Staff Report

Meeting Date: February 27, 2020 (Prepared February 20)

Item: 1785 N. Front Street “Woodburn High School” (CU 2019-07, DR 2019-13, EXCP 2019-07, & PP 2019-03)

1 NORTH ELEVATION - ZONE A - CONDITIONAL USE
1/8" = 1'-0"

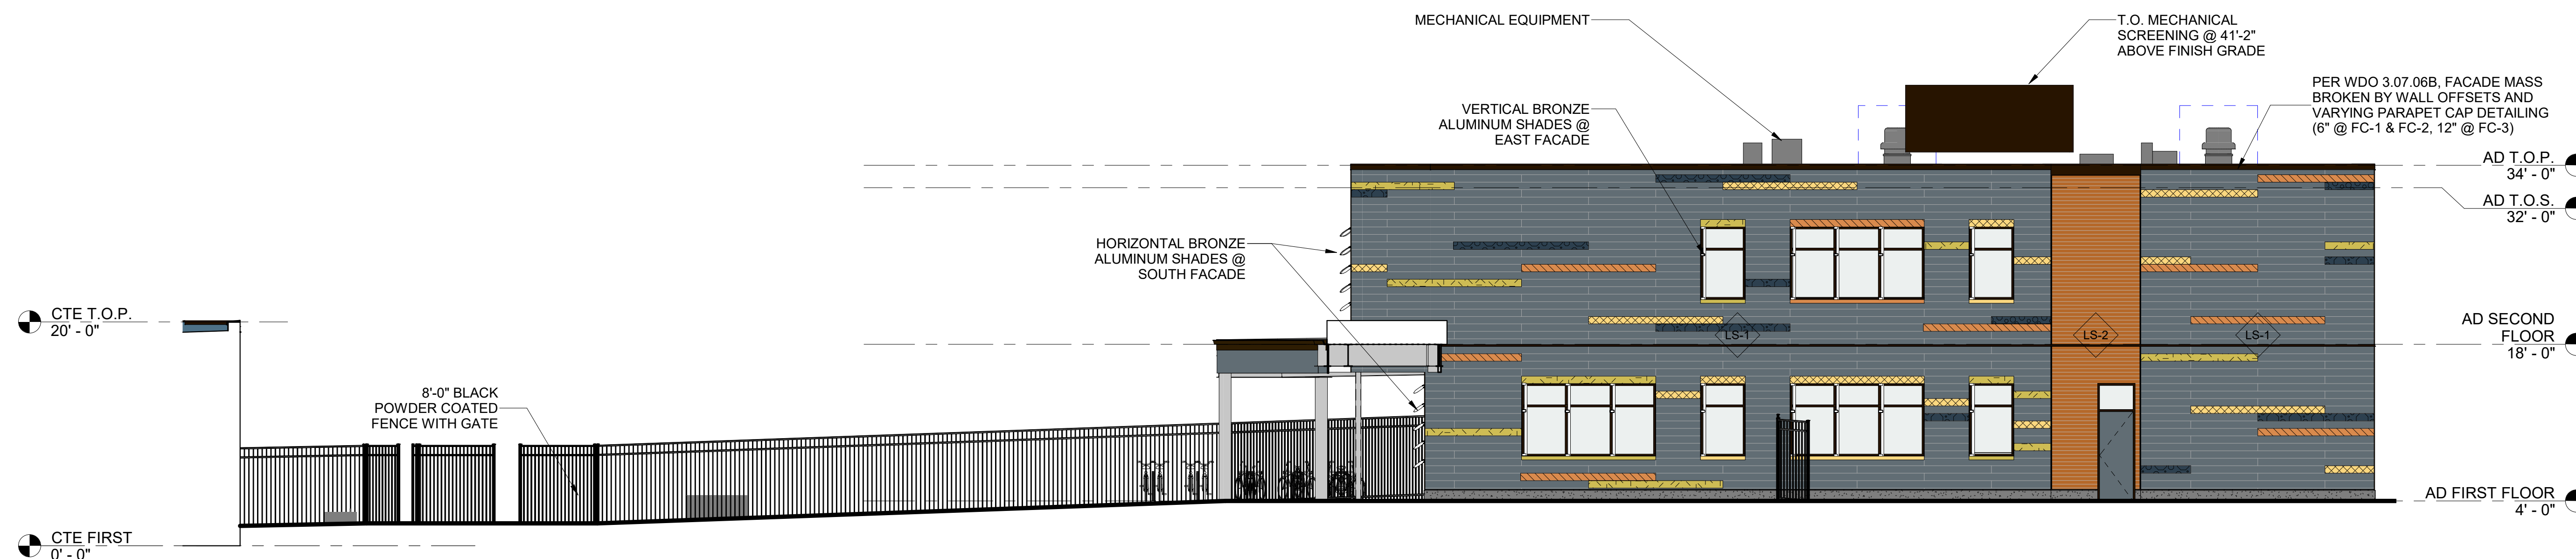
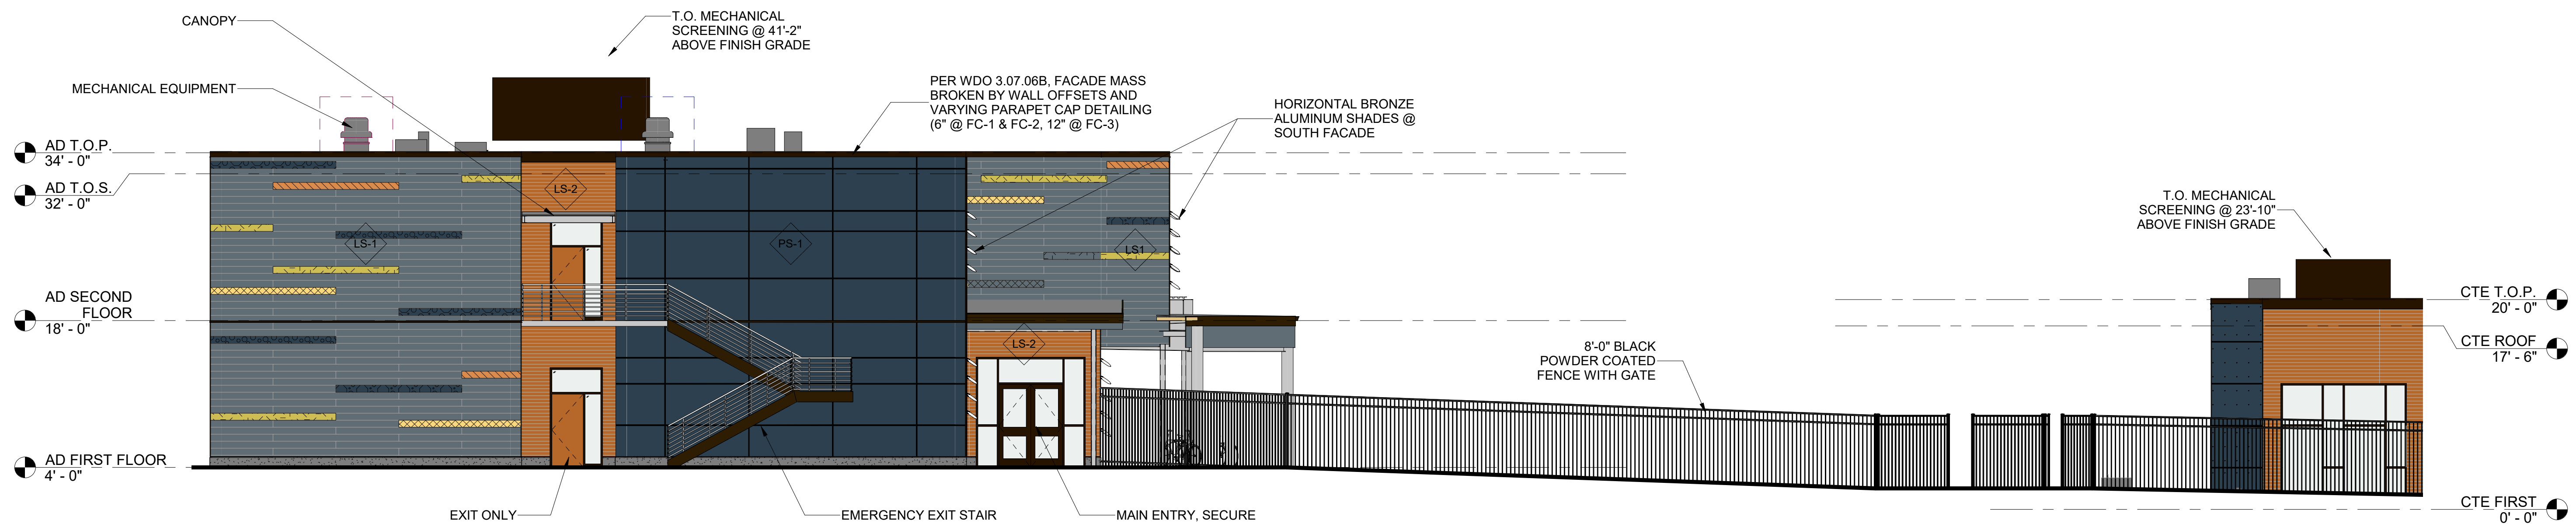
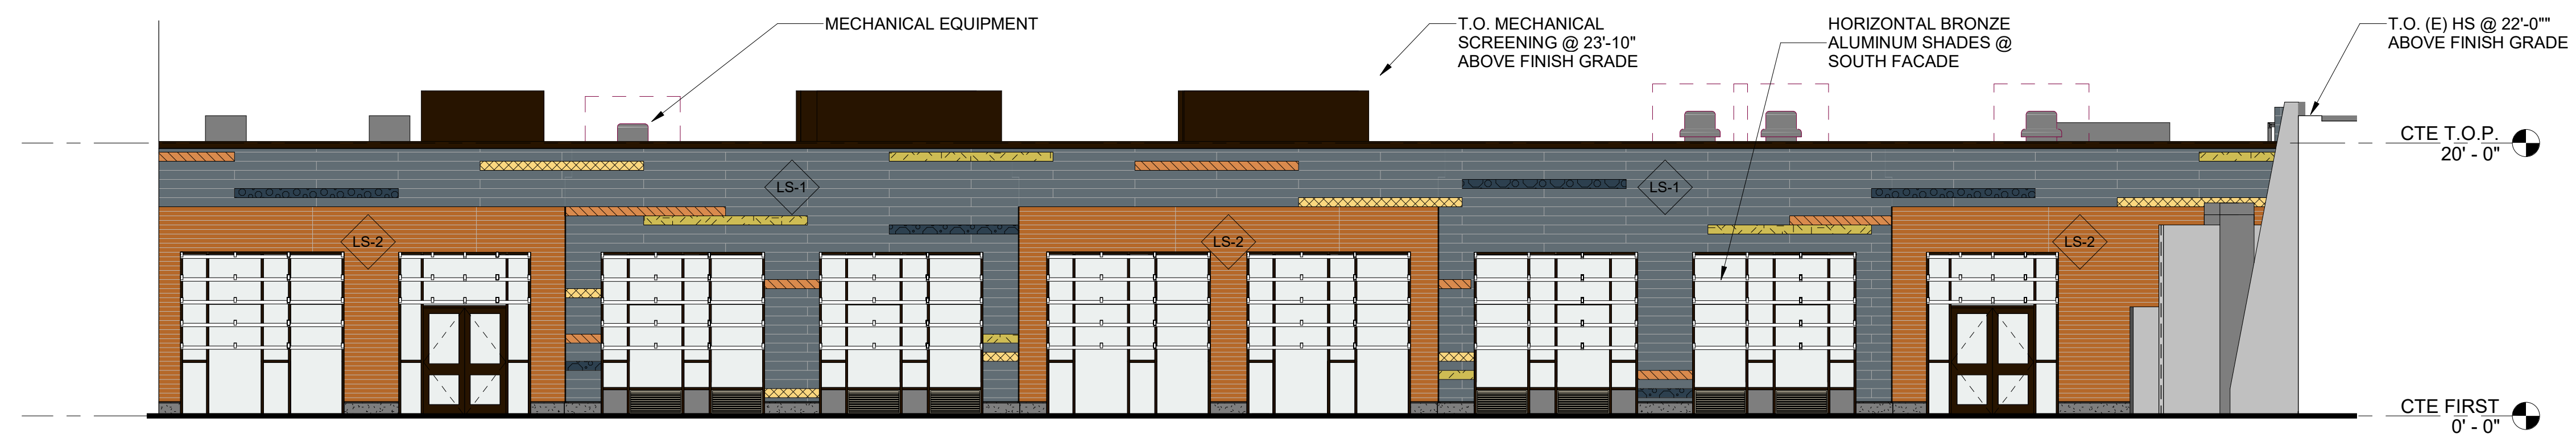
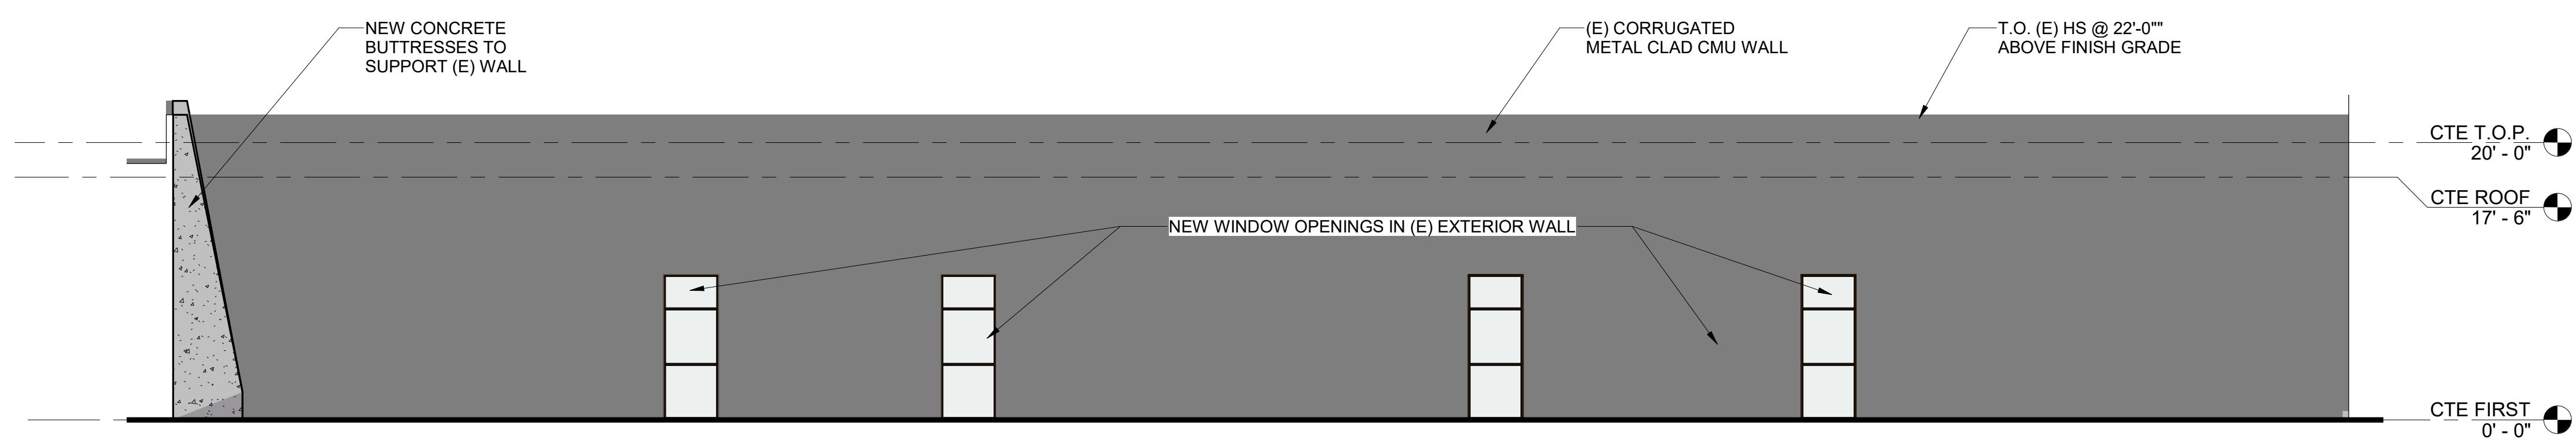
D4. Screening of roof-mounted equipment: To meet WDO 3.07.06B.4 fully, the applicant shall revise the building elevation Sheets CU-A07 through 9 to clarify that all such equipment will be screened.
